# Access Compliance Report

## Public Rights-of-Way

Intersection ID: 45886	Main Street: BEN_LIVINGSTON_RD	Cross Street: OAK_ST	Location:	N
ADA ID: 209309107D6D	Ramp Type: Perp	Initial Pass/Fail: Fail	Overall Compliance: No	Severity Score: 8.75
Codes/Mitigation Info/Possible Solution		Field Measurements/Component Compliance

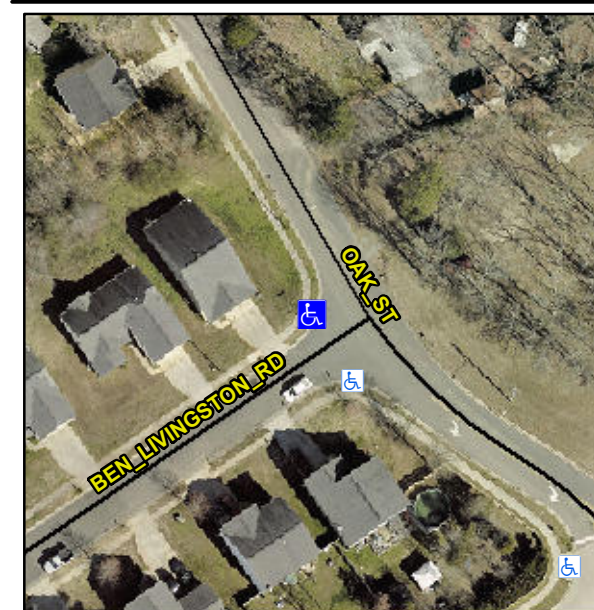
**Not Found, R304.5.1**

Compliance	Description	Data	Compliance	Description	Data
N/A	Ramp Length (in)	48.0	Yes	Ramp Slope (%)	6.8
No	Ramp Width (in)	47.0	Yes	Ramp XSlope (%)	2.0
N/A	Flare Type LT	N/A	N/A	Flare Type RT	N/A
N/A	Flare Slope LT (%)	N/A	N/A	Flare Slope RT (%)	N/A
N/A	Flare Traversable LT?	N/A	N/A	Flare Traversable RT?	N/A
N/A	Landing Length (in)	N/A	N/A	DWS Provided?	N/A
N/A	Landing Width (in)	N/A	N/A	DWS Contrast?	N/A
N/A	Landing Slope (%)	N/A	N/A	DWS Length (in)	N/A
N/A	Landing X Slope (%)	N/A	N/A	DWS Full Width?	N/A
N/A	Landing Curb? (Y/N)	N/A	N/A	DWS Offset (in)	N/A
N/A	Shared Landing?	N/A			
N/A	Gutter Ponding?	N/A	N/A	Gutter Slope (%)	N/A
N/A	Gutter Lip Ht (in)	0.5	N/A	Gutter X Slope (%)	N/A
N/A	Painted X Walk1?	No	N/A	Painted X Walk2?	N/A
	X Walk 1 Direction	To S		X Walk 2 Direction	N/A
N/A	X Walk 1 Width (in)	N/A	N/A	X Walk 2 Width (in)	N/A
	X Walk 1 Slope (%)	0.6		X Walk 2 Slope (%)	N/A
	X Walk 1 X Slope (%)	2.0		X Walk 2 X Slope (%)	N/A

**Remove & Replace Entire Ramp.**
